SCOPE OF PROJECT CHANGES:

PERMIT DRAWINGS

CLARKSON RESIDENCE

1 PROPOSED FOUNDATION PLAN - SEE SHEET SH2.1 FOR PILE LAYOUT
1" = 10'-0"

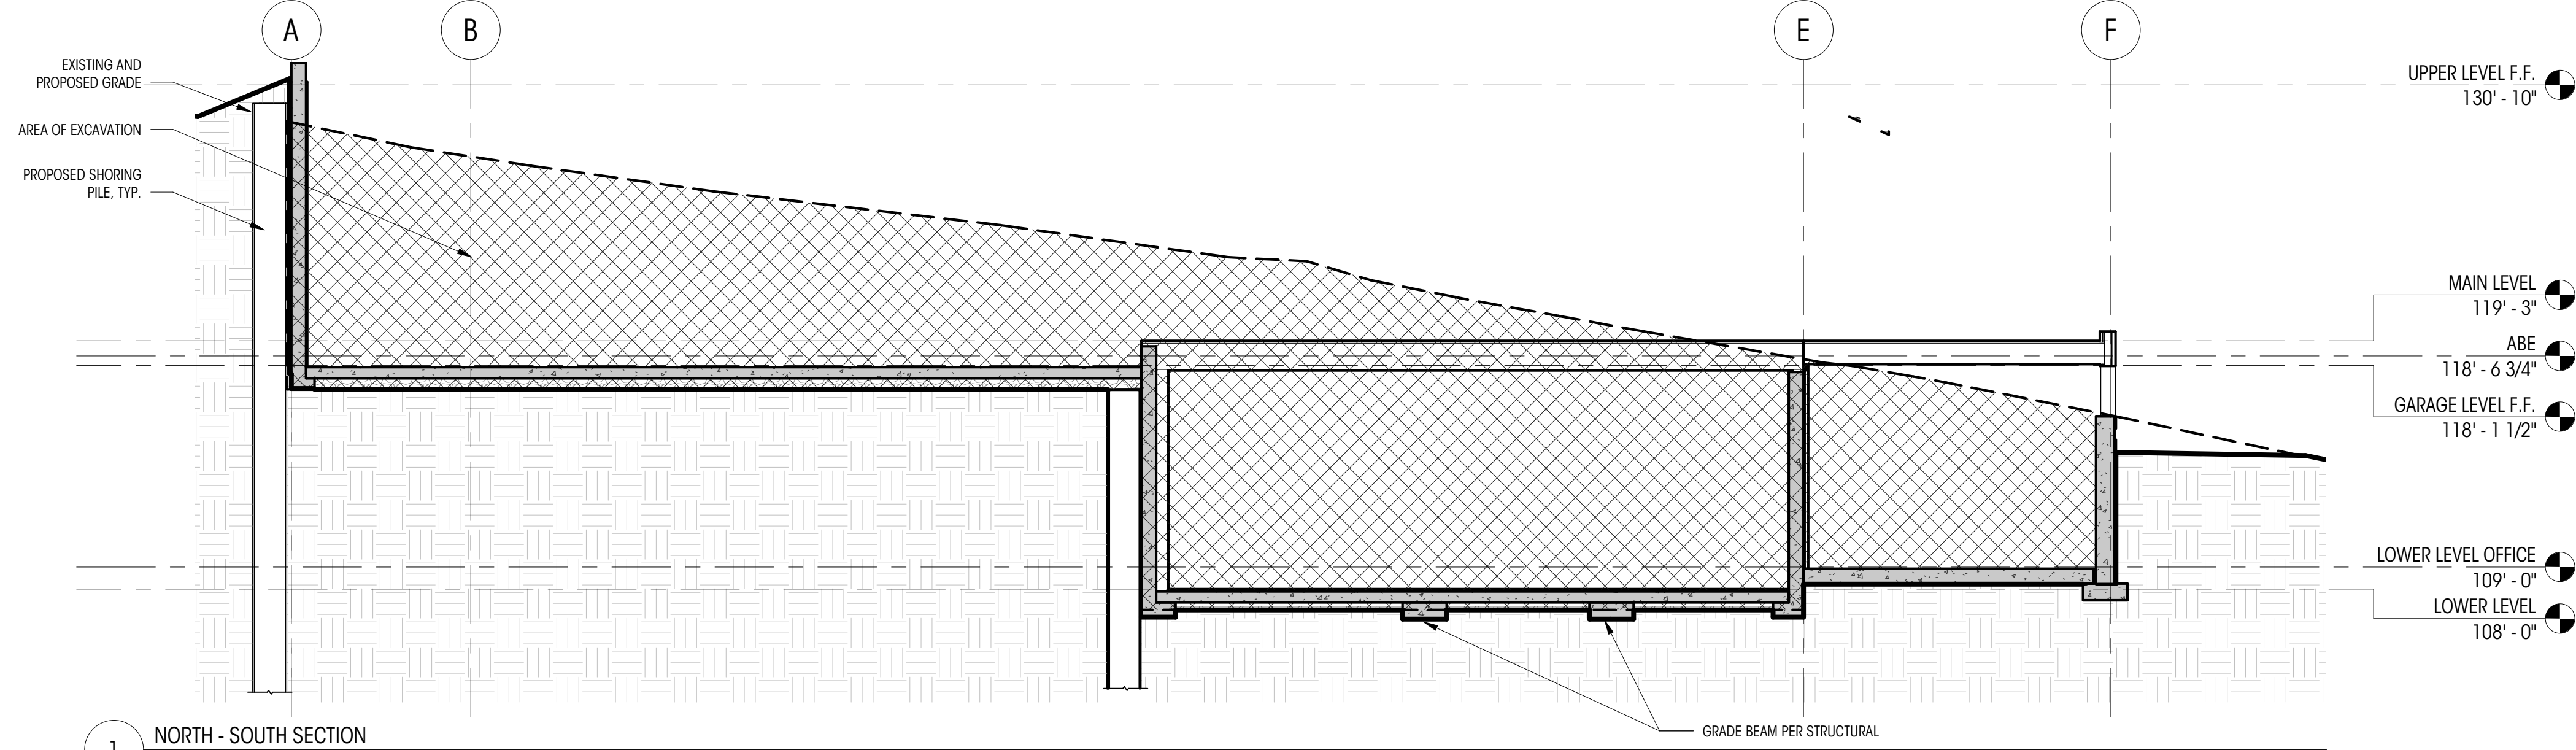
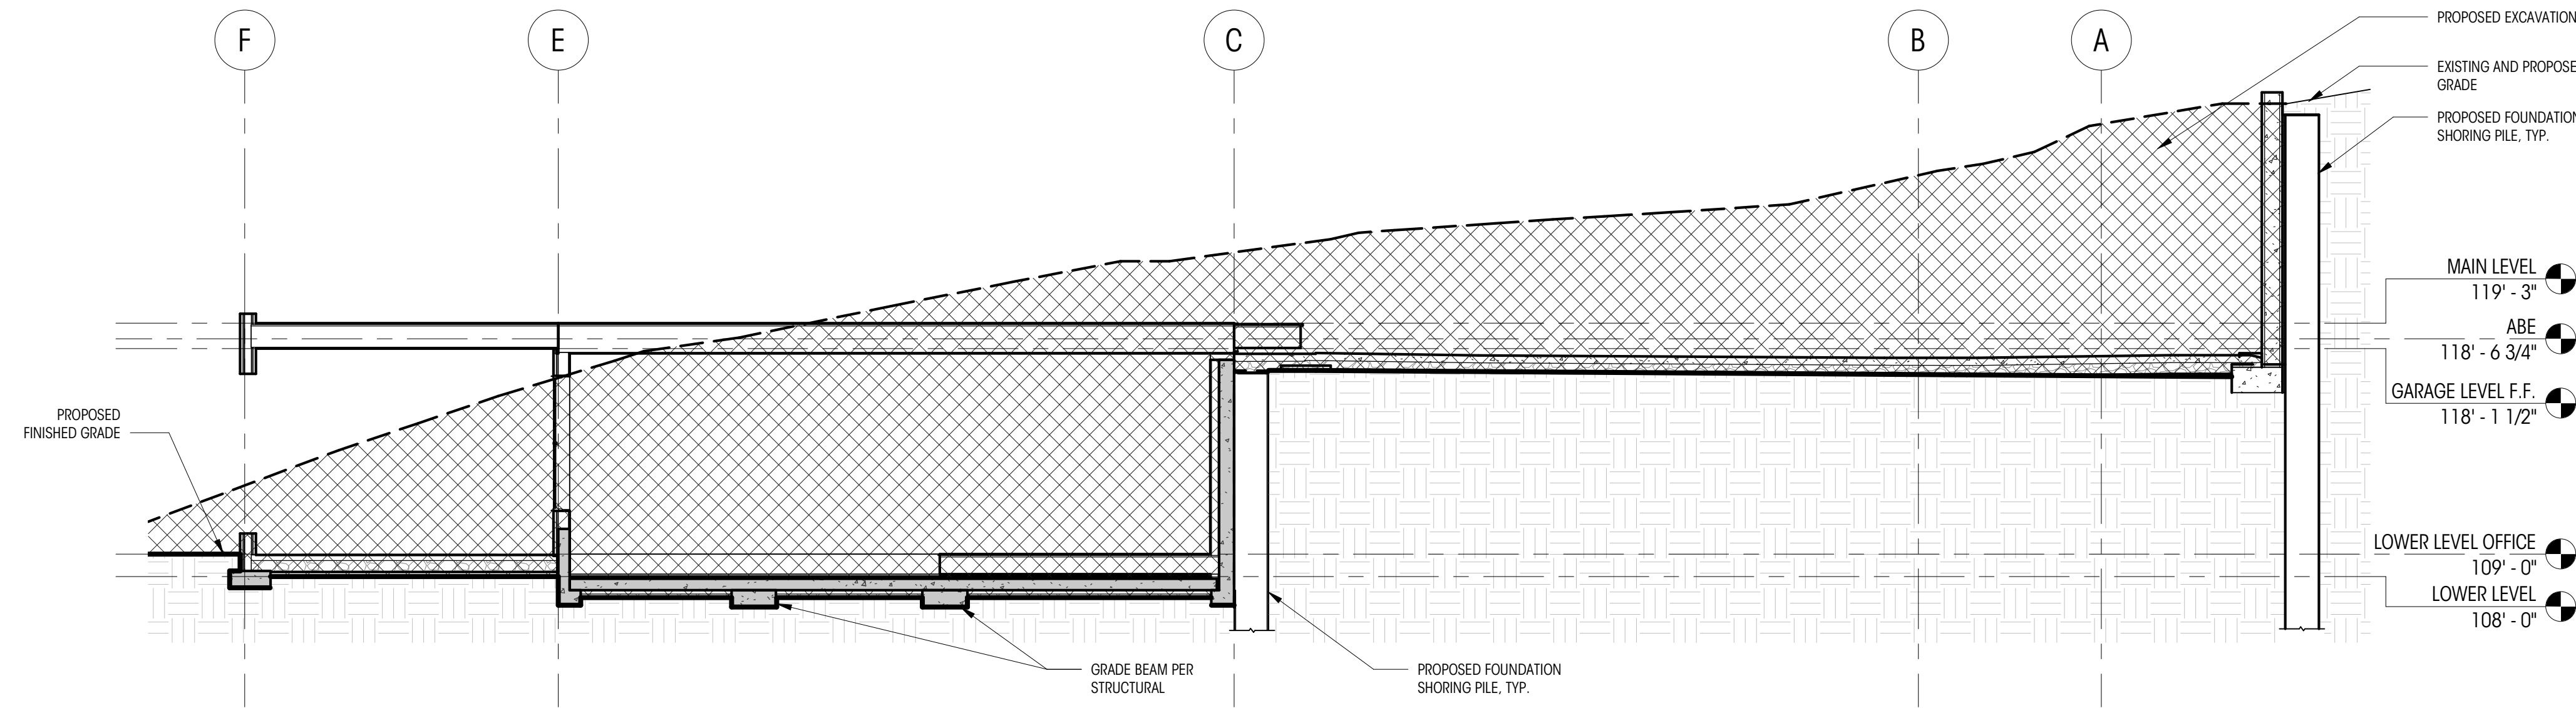
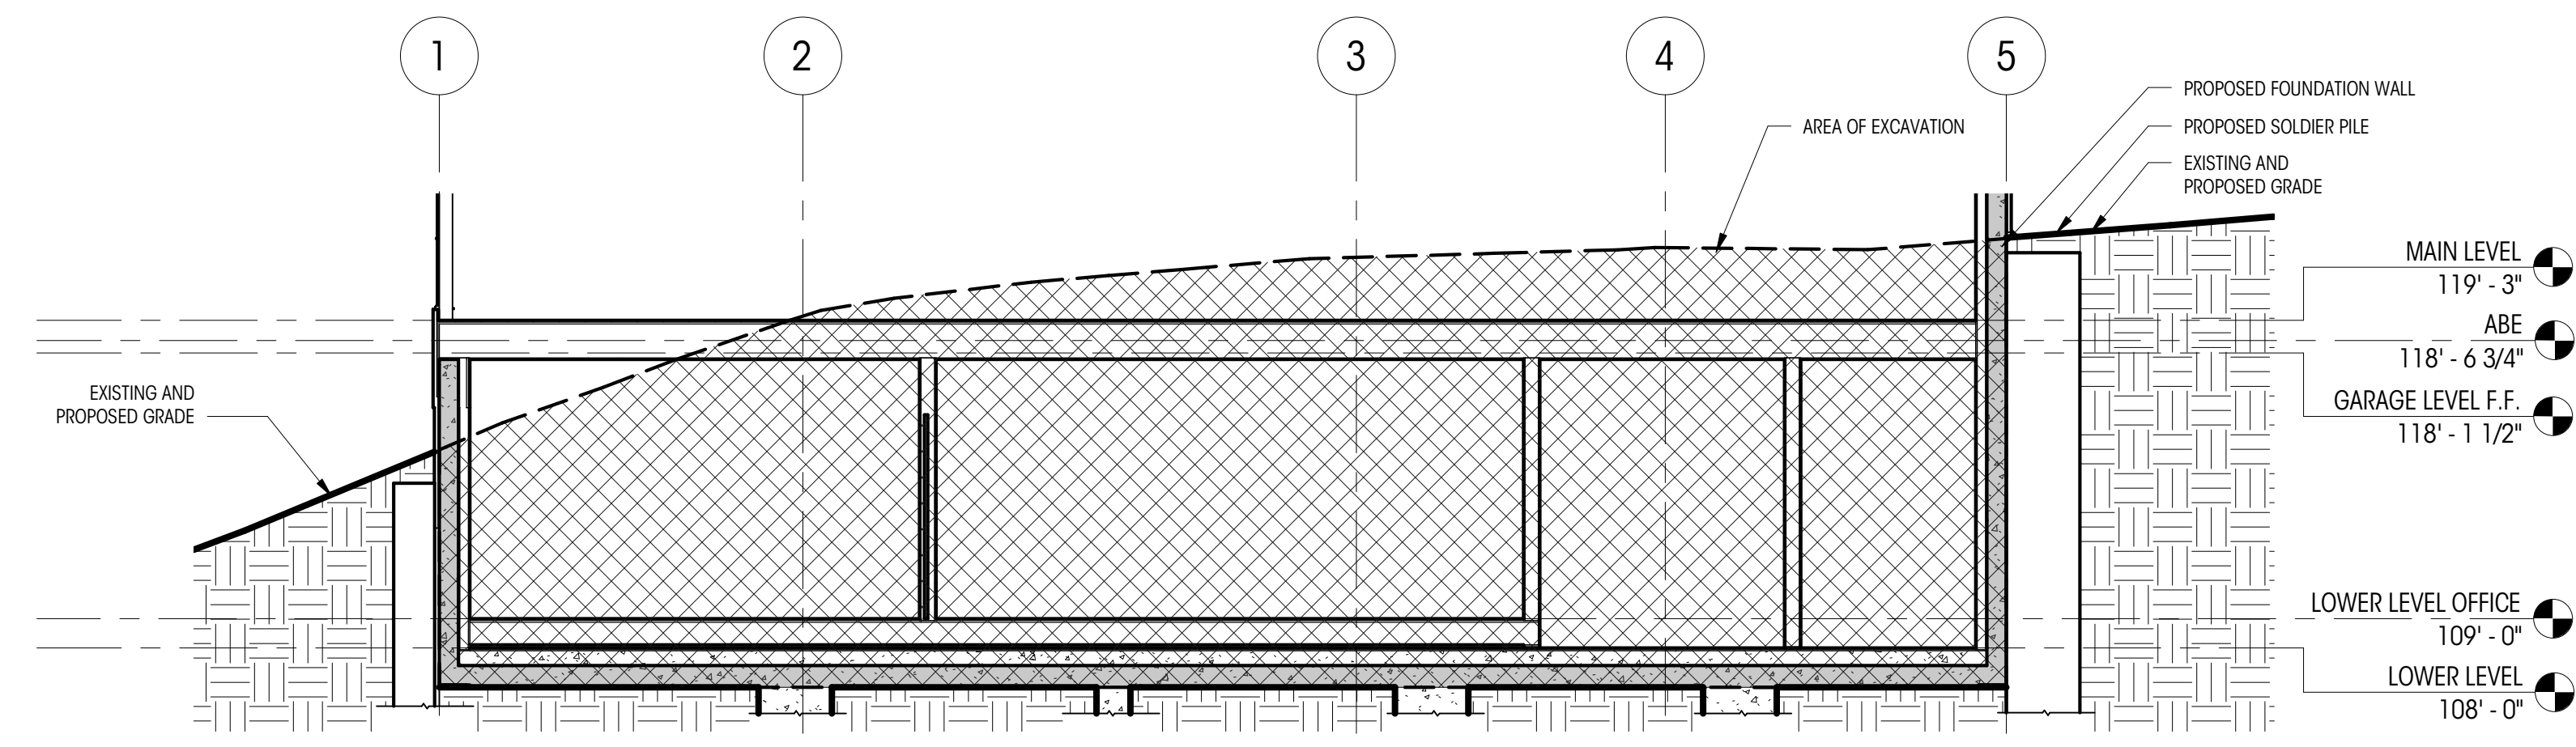
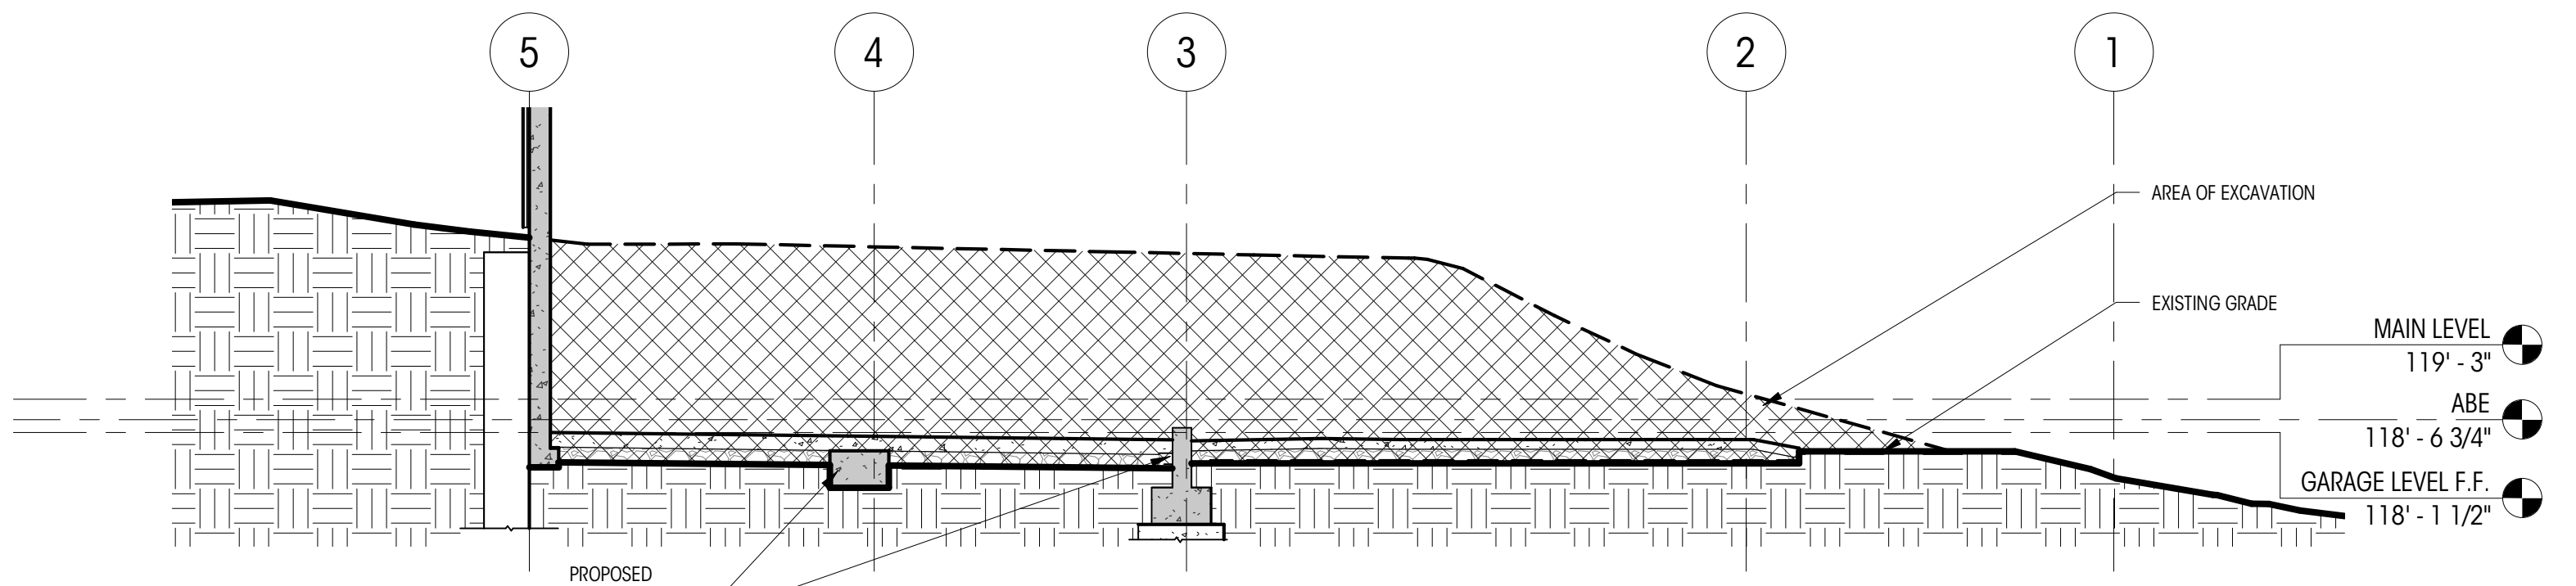
- LEVEL CHANGES: DRIVEWAY & GARAGE LEVEL DROP BY 15"; BASEMENT LEVEL DROP BY 12"
- CHANGE TO ABE AS A RESULT OF EXTENDED GARAGE AND EXTENDED COVERED DECK
- VIEW NUMBERING HAS BEEN UPDATED FOR CONSISTENCY

1 SITE SETBACK & BUILDING PAD PLAN
1" = 10'-0"

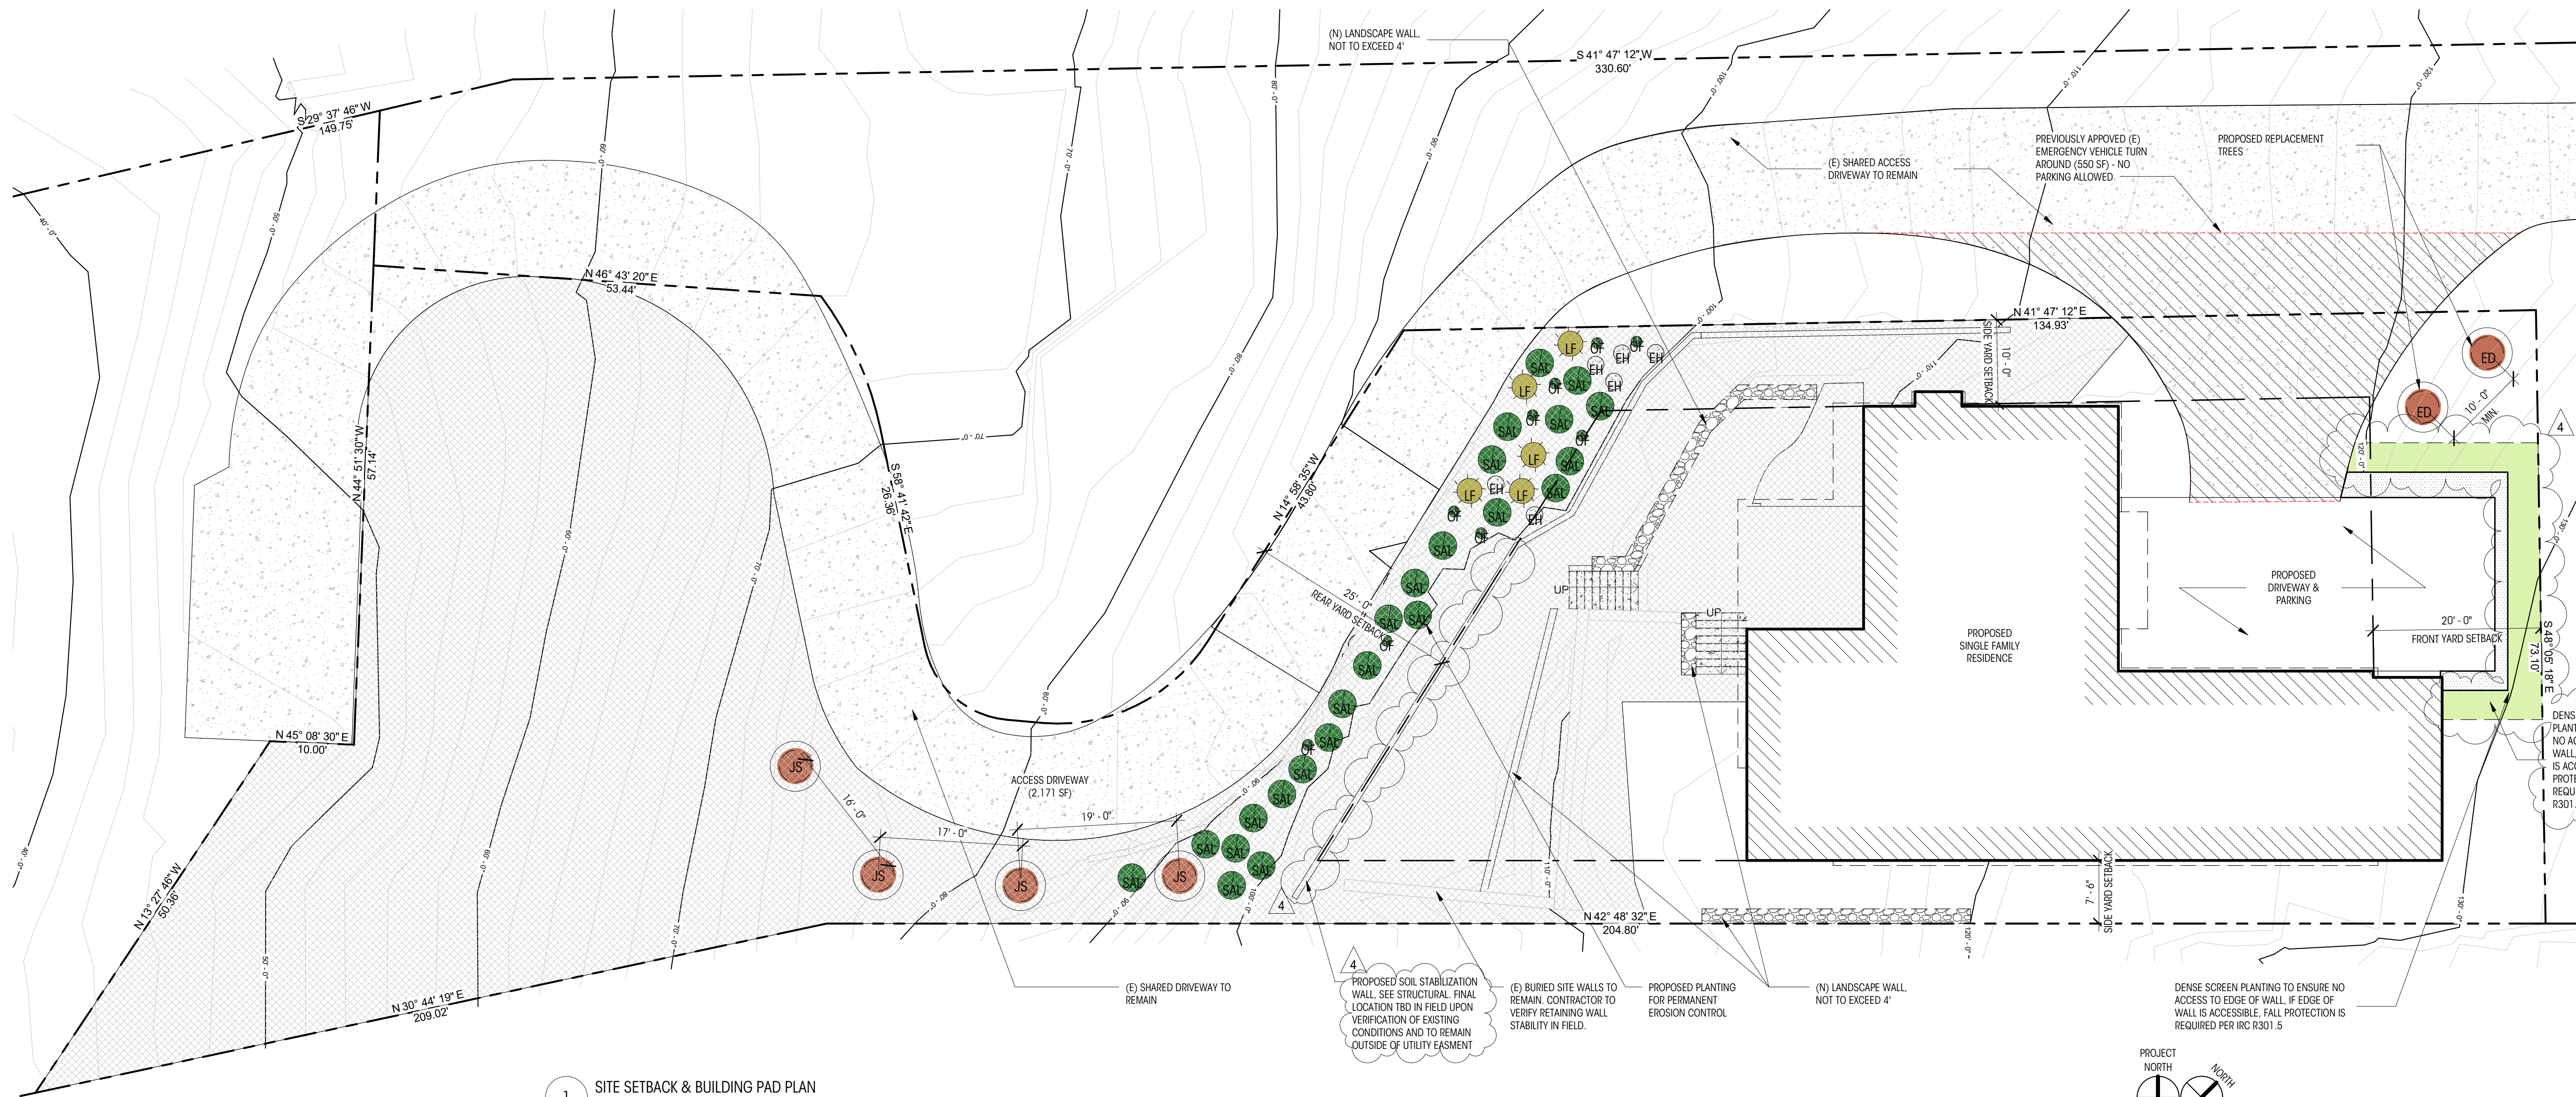
- REVISED LOCATION OF REPLACEMENT TREES
- SHIFT OF PARKING RETAINING WALLS TO NORTH AND SOUTH CHANGE IN SOIL RETENTION WALL: PREVIOUSLY AS PART OF THE FOUNDATION SYSTEM, NOW MOVED TO WESTERN YARD ADJACENT TO ROAD IN ORDER TO ALLOW FOR LANDSCAPE WORK
- REVISED FOUNDATION AS A RESULT OF SOIL STABILIZATION WALL LOCATION MOVE
- CHANGES TO HARDSCAPE CALCULATIONS AS A RESULT OF SOIL STABILIZATION WALL, PATIO EXTENSION AND SITE STAIRS
- GRAPHICS/PATTERNS/HATCHES HAVE BEEN COORDINATED FOR CONSISTENCY
